ADDENDUM NO. 1

RE: Item #2, May 7, 2025 Letting - PT 0025(98)26, ER 0044(253)368, ER 019A(34)28, PT 0044(223)397, PCN 0828, 0A2Y, 0A37, 0829, Hutchinson, Turner County - Scour Protection, Berm Repair, Bank & Channel Protection

FULLY GROUTED RIPRAP

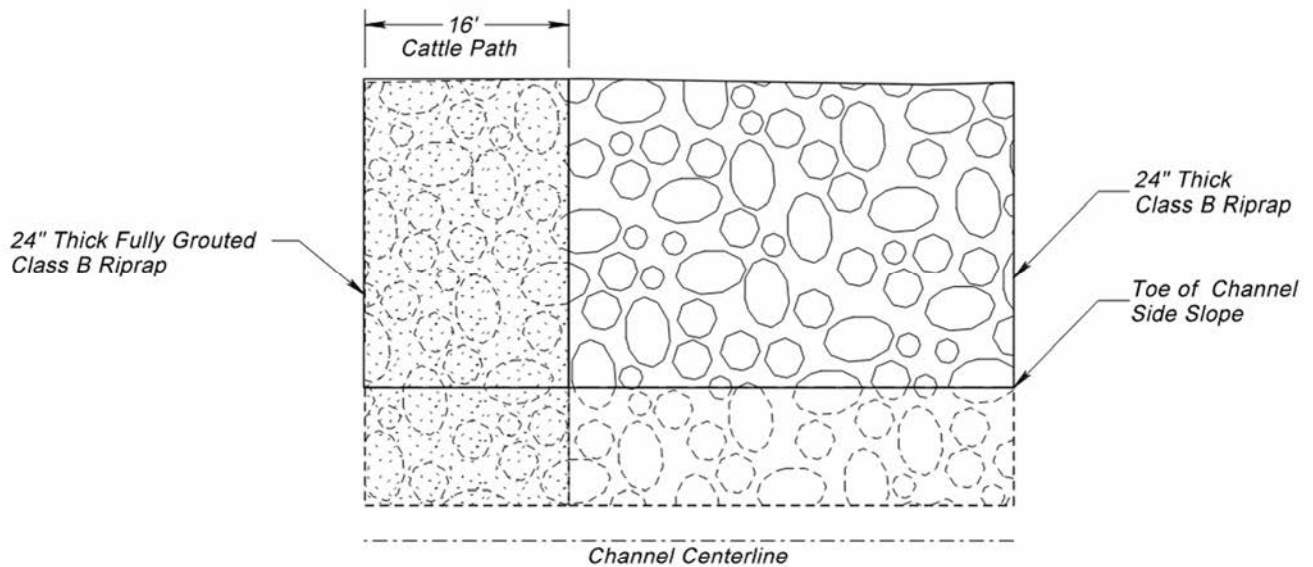
Sheet 7A: FULLY GROUTED RIPRAP note was added.

Sections of riprap being placed with this project will be fully grouted to provide a cattle path over the riprap, to the satisfaction of the Engineer, at locations specified in the plans. Voids in the riprap will be filled with low slump Class M6 Concrete and finished with a cattle path surface. Spud vibrators are required to consolidate the concrete into voids in the riprap. The final cattle path surface will be 16 feet wide and finished with a sufficiently rough surface texture to provide traction for safe passage of cattle over the riprap.

The Contractor will furnish and place Class B stone riprap at the locations shown in the plans, in accordance with Section 700 of the Specifications. Fully Grouted Riprap will conform to the Specifications Section 462 for Class M6 Concrete, and Section 830 for Riprap, Class B.

Measurement of fully grouted riprap will be the weight of the Class B riprap being grouted, measured to the nearest 0.1 ton. All costs associated with the fully grouted riprap including site preparation, furnishing and placement of Class B Riprap and Class M6 Concrete, will be incidental to the contract unit price per ton for "Fully Grouted Riprap".

EASEMENT and EROSION CONTROL LAYOUT

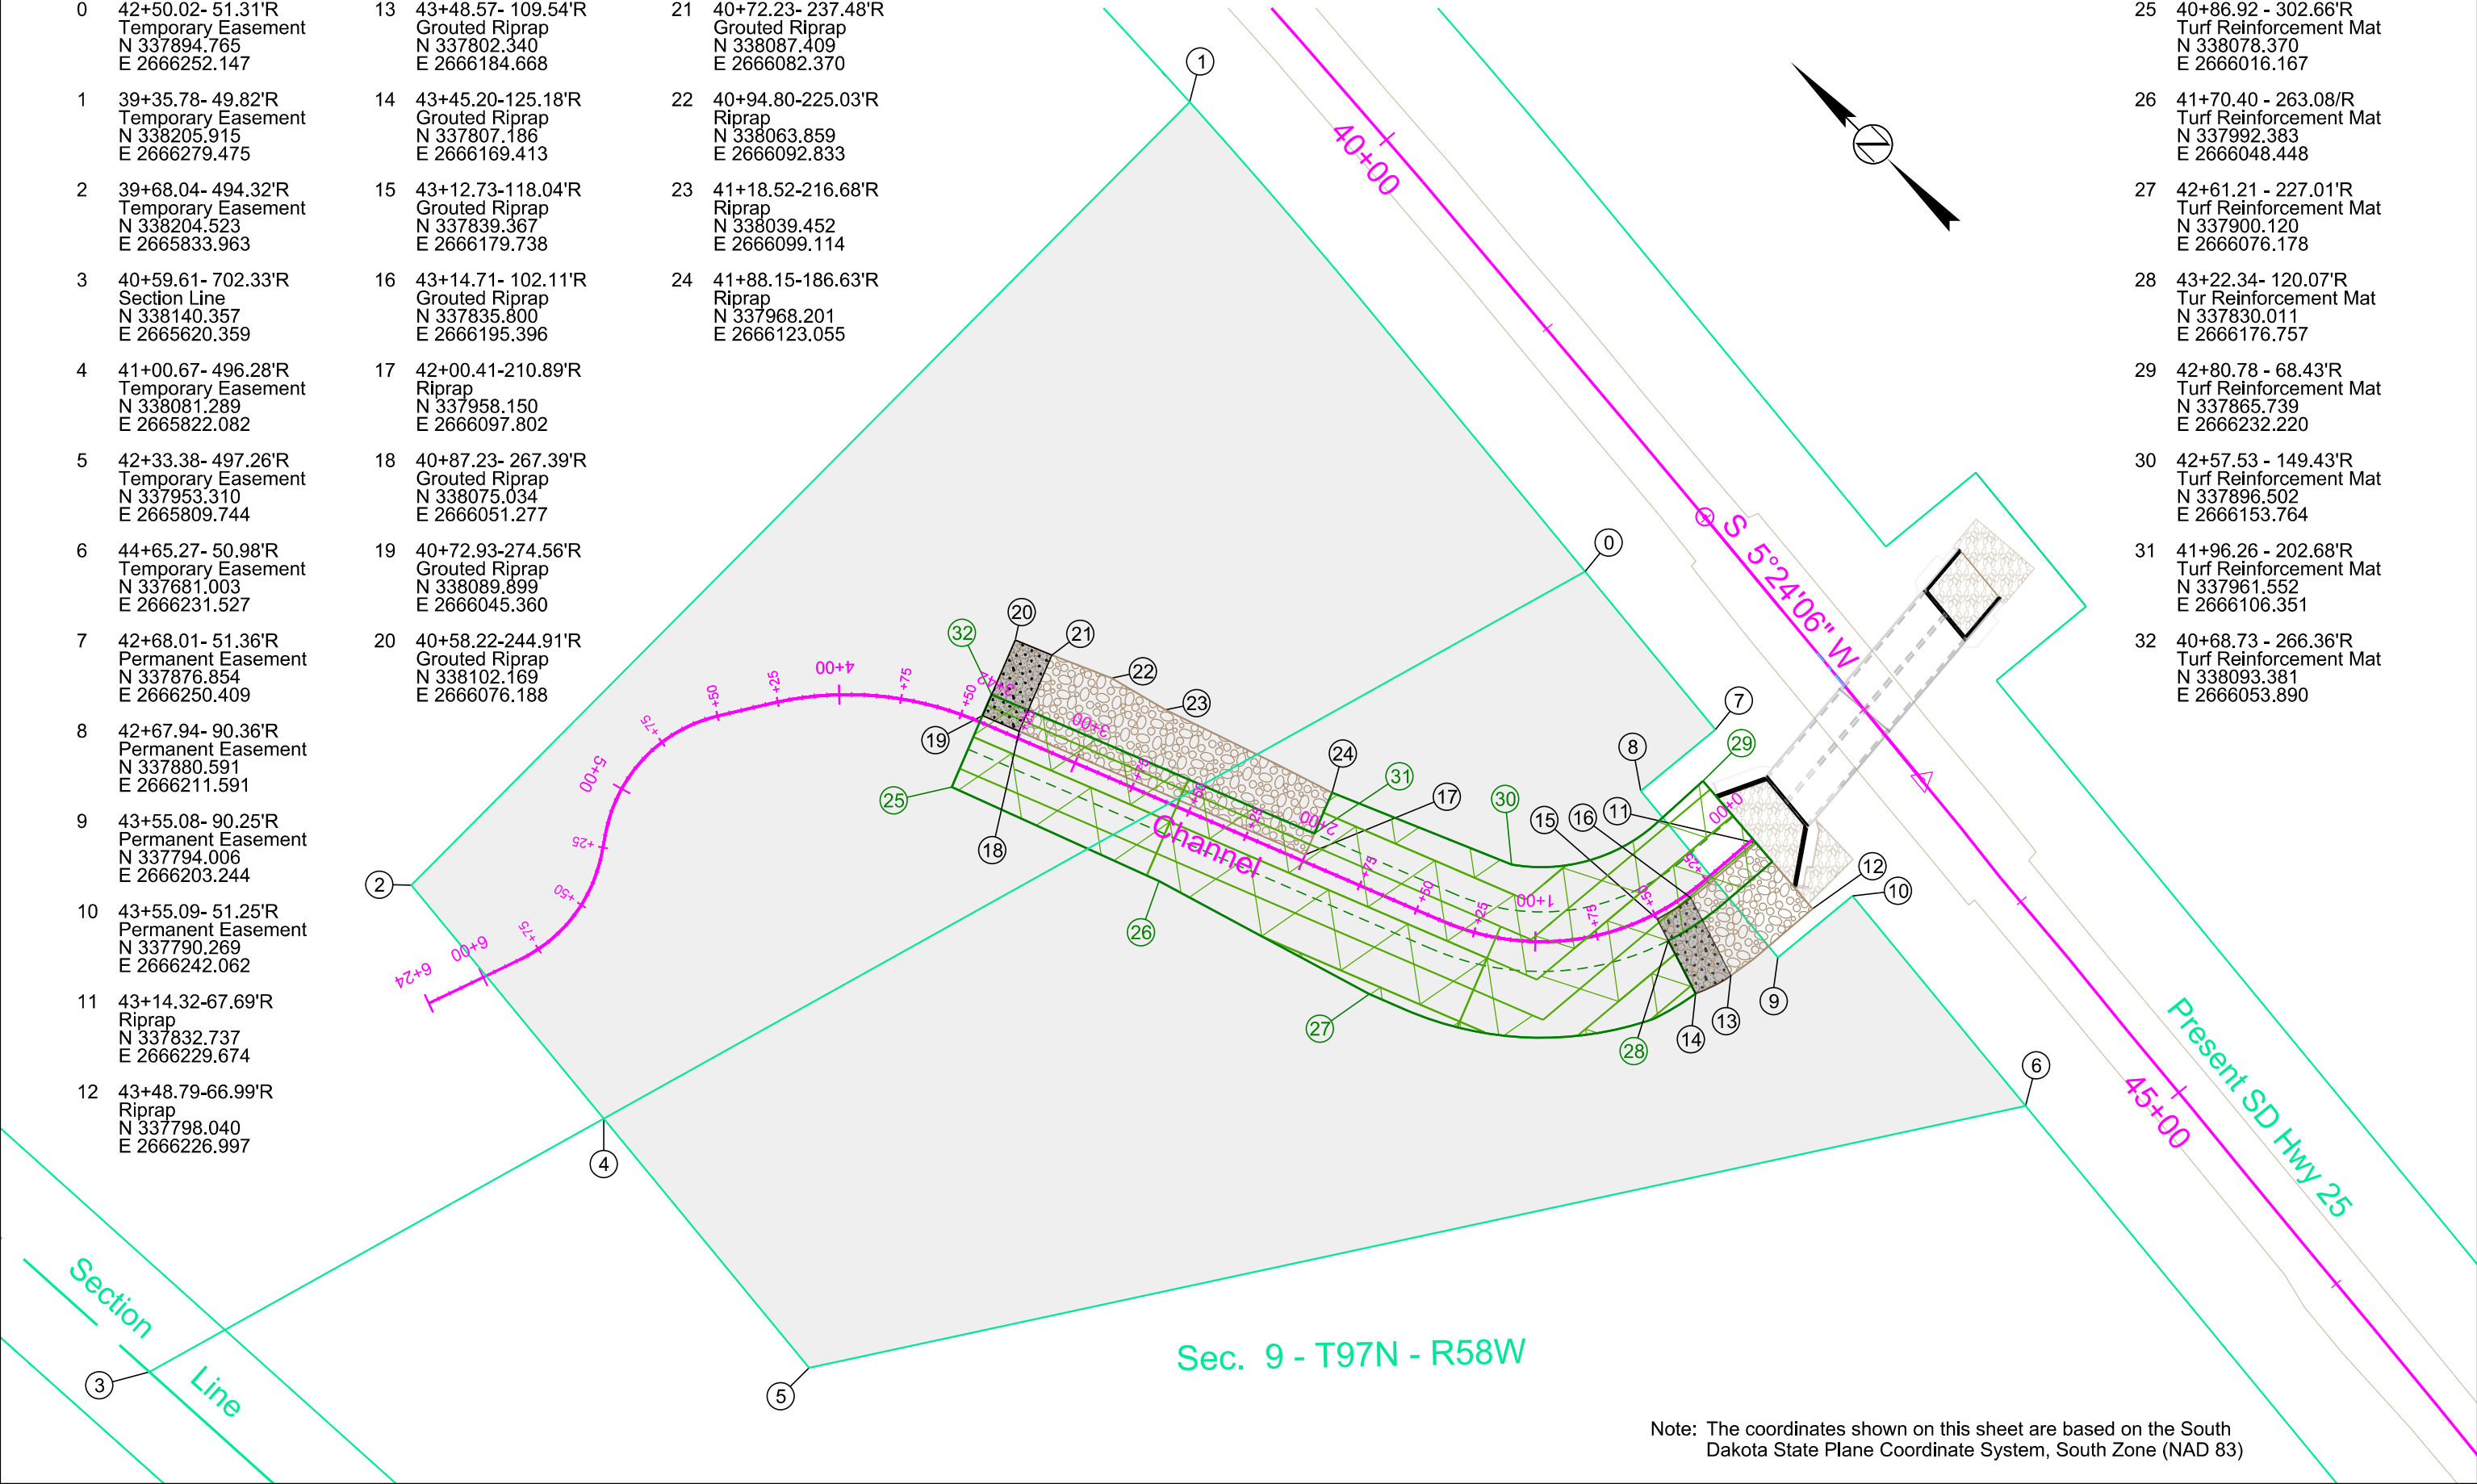
Sheet 19: EASEMENT and EROSION CONTROL LAYOUT was revised.

**LAYOUT FOR UPGRADE
FOR
2 - 12' x 11' BOX CULVERT**

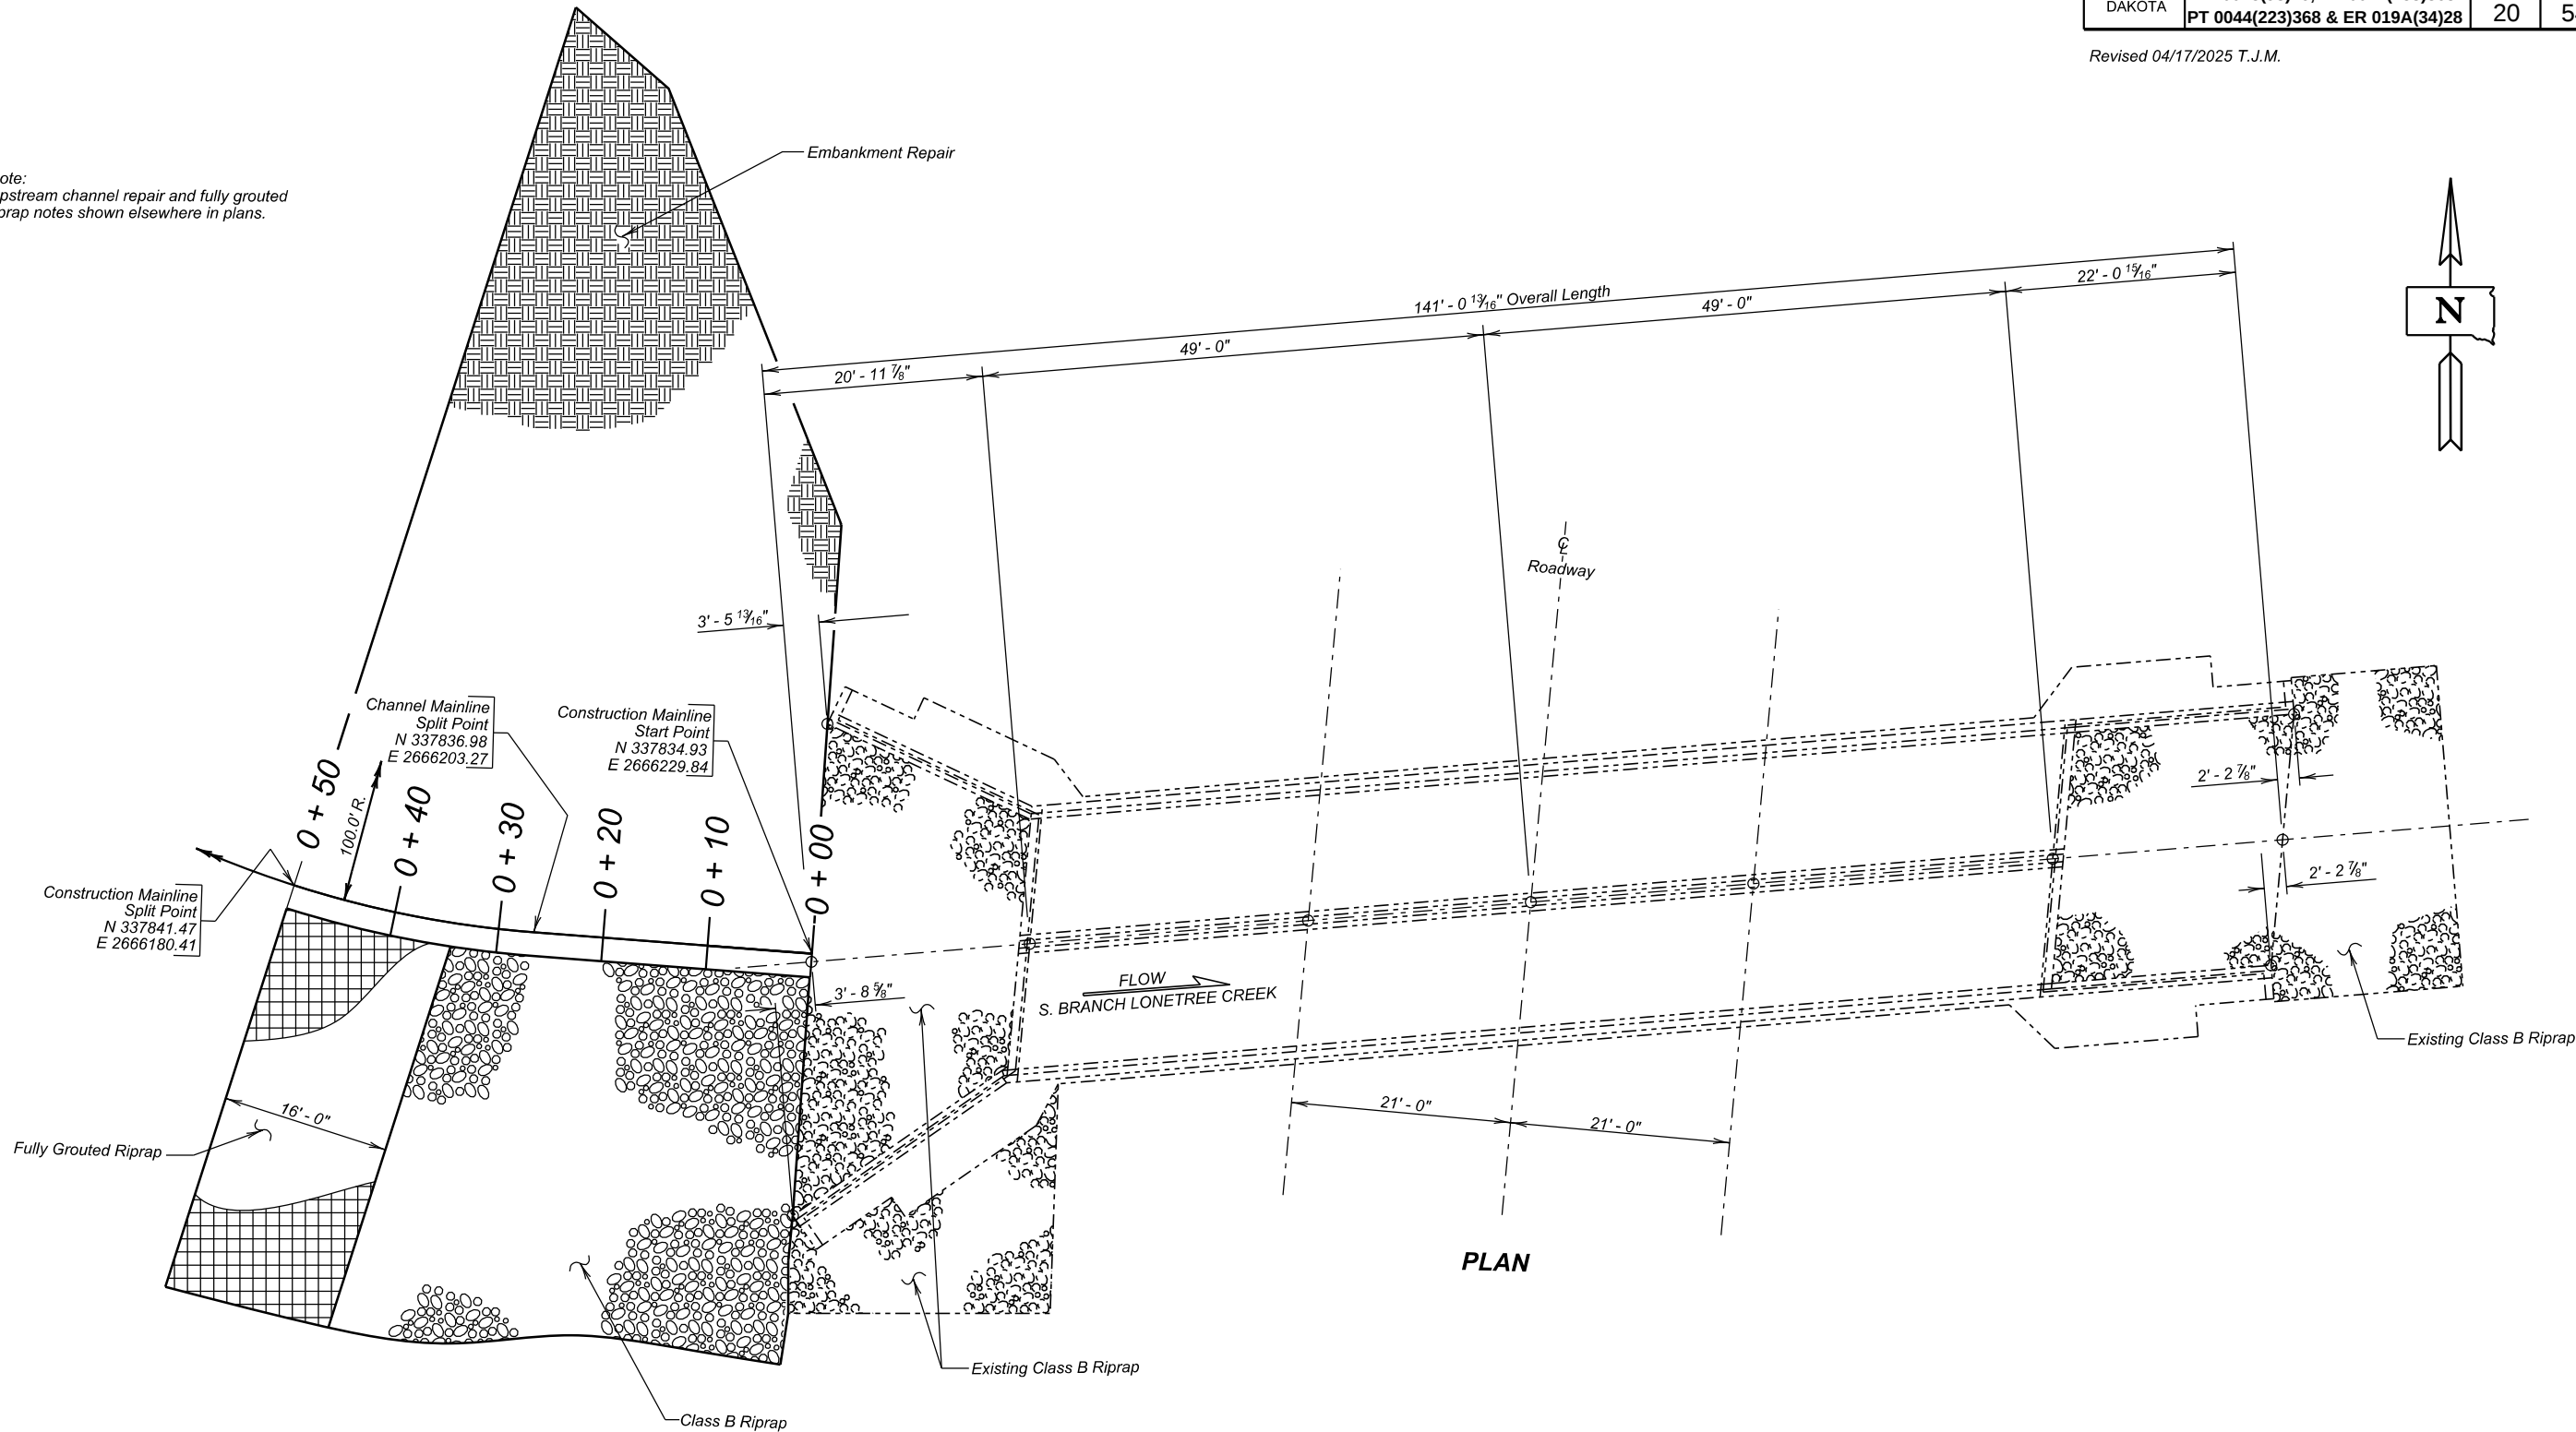
Sheet 20: LAYOUT FOR UPGRADE was revised to show fully grouted riprap location.

ESTIMATE OF STRUCTURE QUANTITIES AND NOTES
FOR
2 - 12' x 11' BOX CULVERT

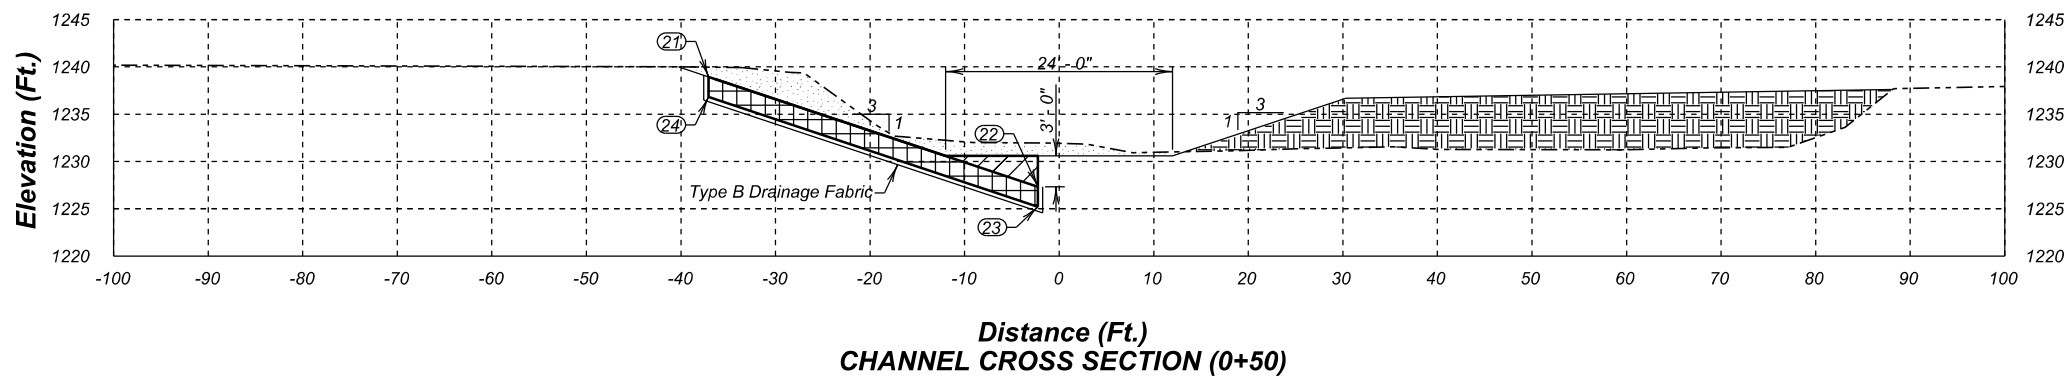
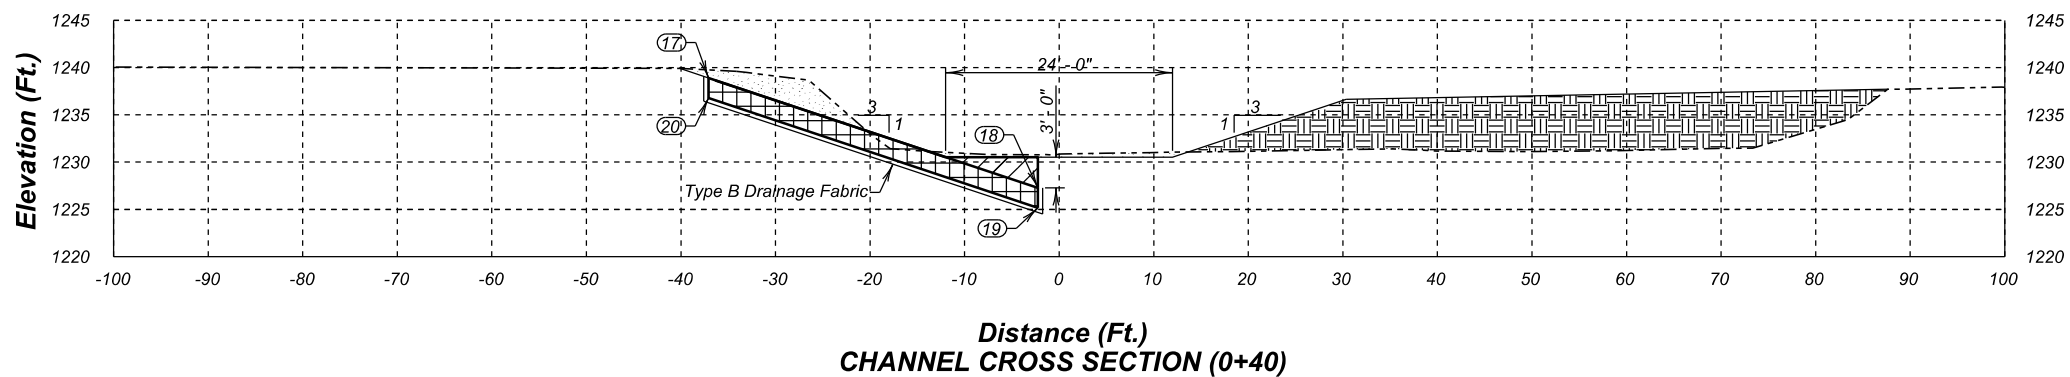
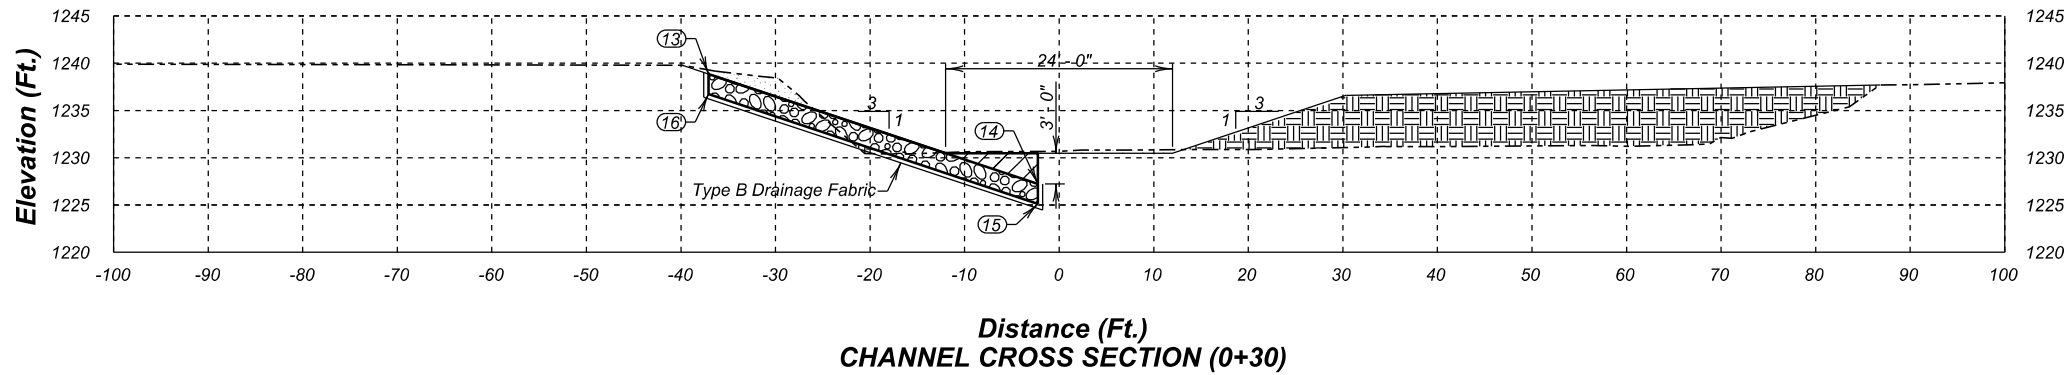
Sheet 21: Bid Item 700E1250 "Fully Grouted Riprap" was added and Quantities for Bid Item 700E0210 "Class B Riprap" changed from 190.0 to 134.0 Ton.
RIPRAP notes were revised.

8. The Class B Riprap and Fully Grouted Riprap will be constructed to the configuration, limits and elevations shown. The stream banks in the areas of riprap placement will be reconstructed as shown and approved by the Engineer. Cost of reconstructing the stream banks will be incidental to the contract unit price bid for Class B Riprap or Fully Grouted Riprap as appropriate.
